Braces for Cascadia Cab-Mounted Splash Shields

88-44

Freightliner
Service Bulletin

Description of Revisions: *This bulletin replaces the version dated February 2012. The splash shield removal and installation are added, and the warranty tables are revised.*

Fig. 1, Splash Shield Brace Installation

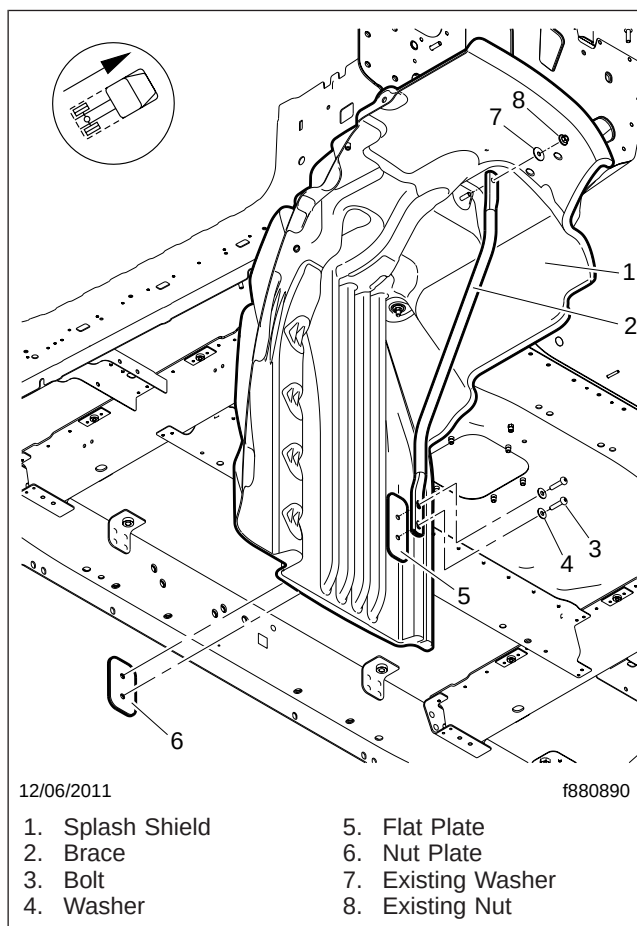
On some Cascadia 125 vehicles, the cab-mounted splash shields may crack. A brace has been designed to re-inforce the splash shields and prevent cracking. Use the procedure in this bulletin to replace the broken splash shield(s), and to install braces on both splash shields.

3. For better access to the wheel well, steer the wheel on the affected side to point inboard.
4. If installing the brace on an undamaged splash shield, remove the nut and washer that attach the splash shield to the cab front wall.
5. Using the nut and washer, attach the upper end of the brace to the front-wall stud. Tighten the nut 15 lbf·ft (21 N·m). See [Fig. 1](#).
6. The lower end of the brace fits into the groove on the inboard side of the splash shield. Using the brace as a template, mark the centers of two holes to be drilled into the splash shield.
7. Using a 3/8-inch (9-mm) bit, drill two holes in the splash shield.
8. Assemble the flat plate, the two washers, and the two screws with the lower end of the brace. Position the nut plate on the aft side of the splash shield, then secure all items together. Tighten the screws 12 lbf·ft (16 N·m).
